Clash Detection Report

We decided to do a clash test between the structural and the HVAC Model. This gave an initial value of 48 clashes. We have decided to solve the first three clashes, as indicated below:

Clash 1

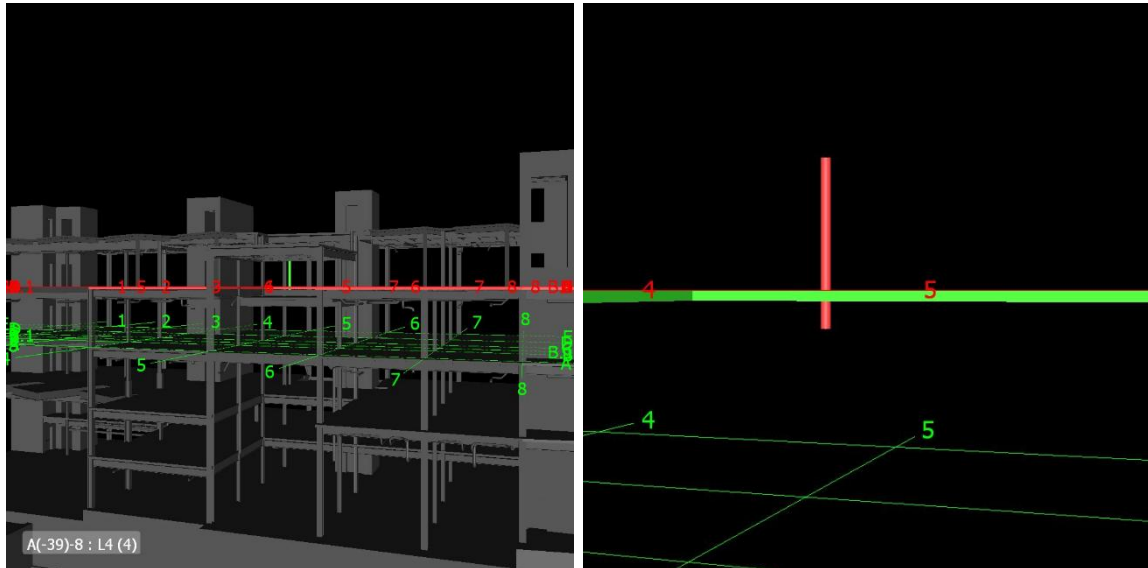
On grid D-5 at level L4, a round duct tee runs confidently through the ceiling zone, only to run straight into a concrete floor slab above. Both elements sit on layer L5, which means the duct and the NW concrete-on-metal-deck floor are competing for exactly the same vertical space. In practice, this reads as a mechanical service trying to pass through a structural floor without a proper opening or coordination.

Clash 2

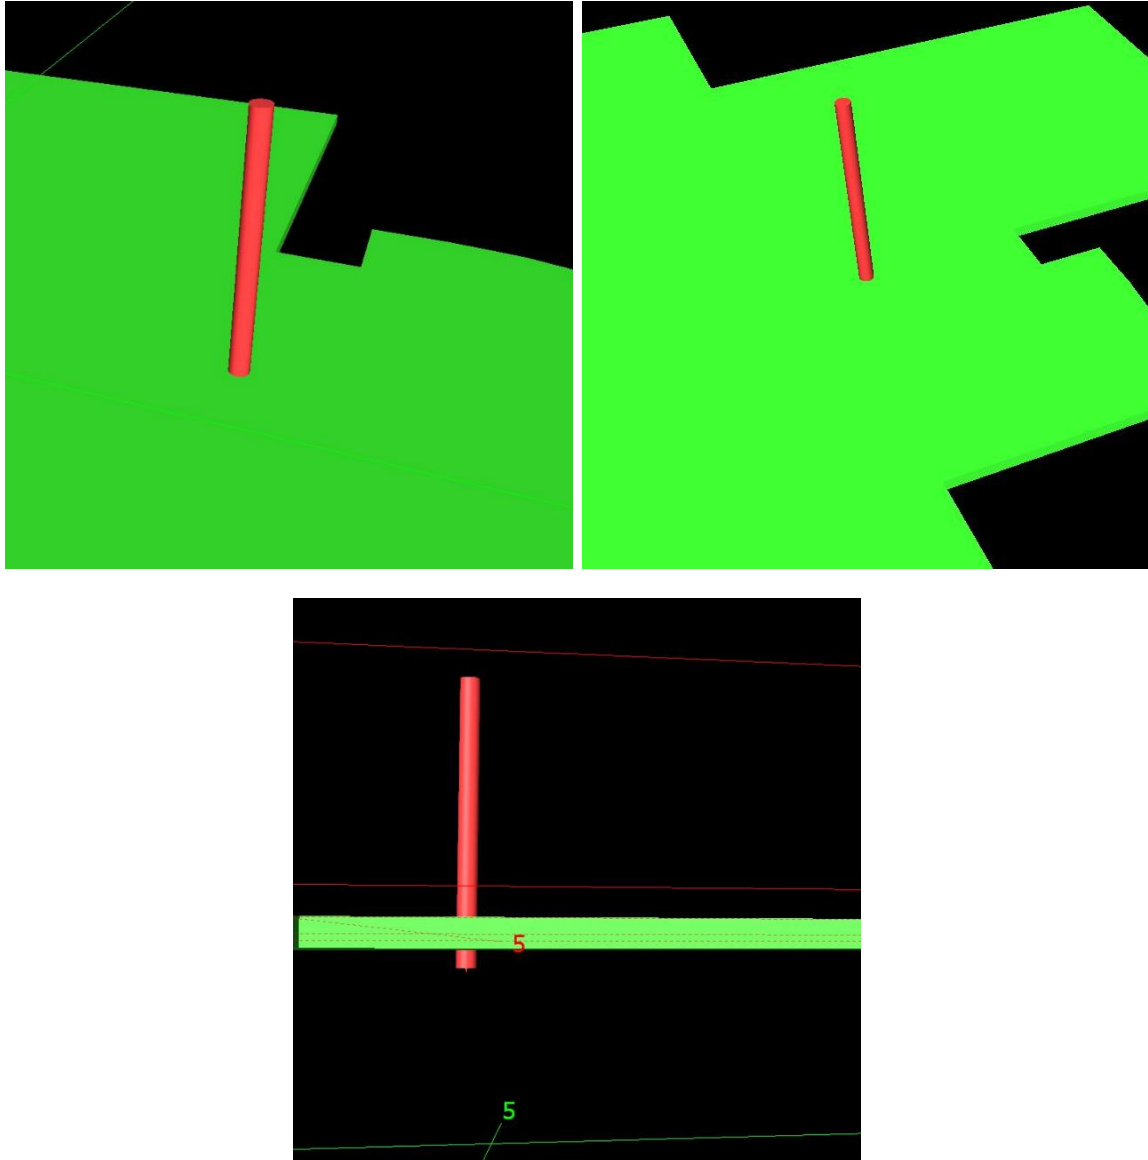
A little lower in the building, still at grid D-5 but on level L2, another round duct tee tries to thread its way through the structure. This time the duct sits on layer L2 while a concrete floor from level L3 drops into its path, so the Level 2 ductwork is pushing up into the underside of the Level 3 slab. The clash shows a vertical coordination issue between the mechanical distribution at L2 and the structural floor system above.

Clash 3

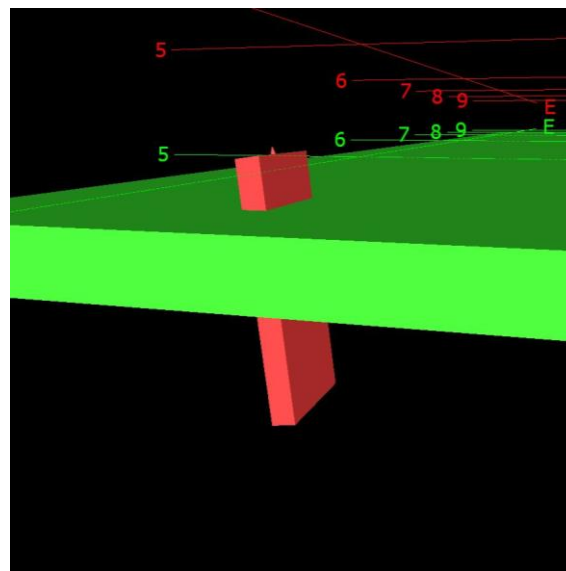
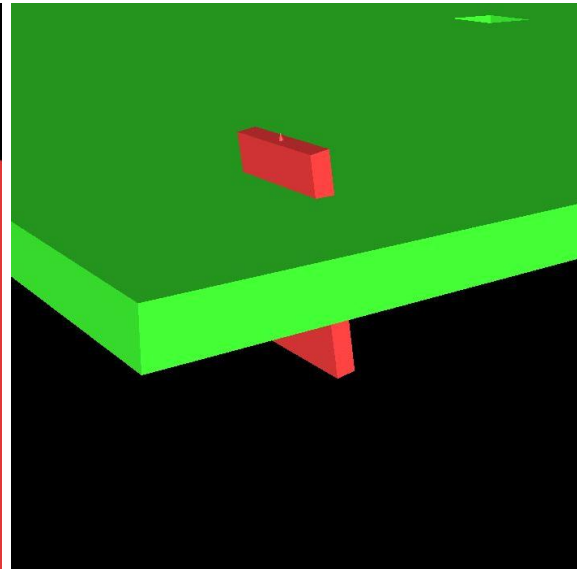
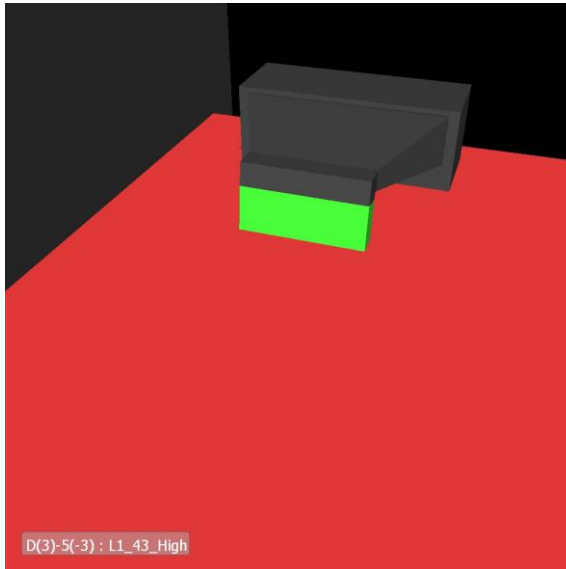
Over at grid E-4 on level L1 in Block 35, the conflict shifts into the parking area where a rectangular duct with mitered elbows attempts to navigate through a tight zone. The duct, assigned to the Parking layer, collides with a relatively thin “Concrete 10” floor on layer L1_37_Med, indicating that the parking ventilation route slices into the structural floor plane. This clash highlights a coordination problem between the parking ventilation strategy and the slab geometry at that block and level.
